## Access Compliance Report Public Rights-of-Way (Curb Ramps)

Intersection ID: 10020377 Main Street: BALLANTYNE\_CORPORATE\_PCross Street: N/A Location: NE

ADA ID: B1595B73AC33 Ramp Type: PerpDiag Initial Pass/Fail: Fail Overall Compliance: No Severity Score: 31.25

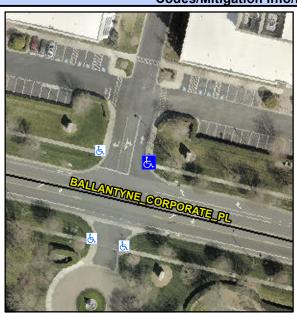
R304.5.1, R304.2.2, R304.5.3

Field Measurements/Component Compilance					
Compliance Description		Data	Compliance Description		Data
N/A	Ramp Length (in)	58.0	No	Ramp Slope (%)	8.6
No	Ramp Width (in)	35.0	No	Ramp XSlope (%)	2.6
N/A	Flare Type LT	N/A	N/A	Flare Type RT	N/A
N/A	Flare Slope LT (%)	N/A	N/A	Flare Slope RT (%)	N/A
N/A	Flare Traversable LT?	N/A	N/A	Flare Traversable RT?	N/A
N/A	Landing Length (in)	N/A	N/A	DWS Provided?	N/A
N/A	Landing Width (in)	N/A	N/A	DWS Contrast?	N/A
N/A	Landing Slope (%)	N/A	N/A	DWS Length (in)	N/A
N/A	Landing X Slope (%)	N/A	N/A	DWS Full Width?	N/A
N/A	Landing Curb? (Y/N)	N/A	N/A	DWS Offset (in)	N/A
N/A	Shared Landing?	N/A			
N/A	Gutter Ponding?	N/A	N/A	Gutter Slope (%)	N/A
N/A	Gutter Lip Ht (in)	N/A	N/A	Gutter X Slope (%)	N/A
N/A	Painted X Walk1?	No	N/A	Painted X Walk2?	No
	X Walk 1 Direction	To NW		X Walk 2 Direction	To SW
N/A	X Walk 1 Width (in)	N/A	N/A	X Walk 2 Width (in)	N/A
	X Walk 1 Slope (%)	9.8		X Walk 2 Slope (%)	4.6

X Walk 1 X Slope (%)	0.7		X Walk 2 X Slope (%)	8.0
N/A	Ramp inside XWalk1?	N/A	N/A	Ramp inside XWalk2?	N/A
	Road Slope (%)	1.4	N/A	Clear Space?	N/A
	Road X Slope (%)	6.5	N/A	Clear Space to XWalk (in)	N/A
N/A	Any Obstructions?	N/A	N/A	Storm Grate/Utility Hazard?	N/A
	Obstruction Type		l	Storm Grate/Utility Type	
		N/A			N/A
			Yes	Surface Condition? (G/P)	Good

Remove & Replace Curb Ramp With Two New Directional Ramps or Equivalent.
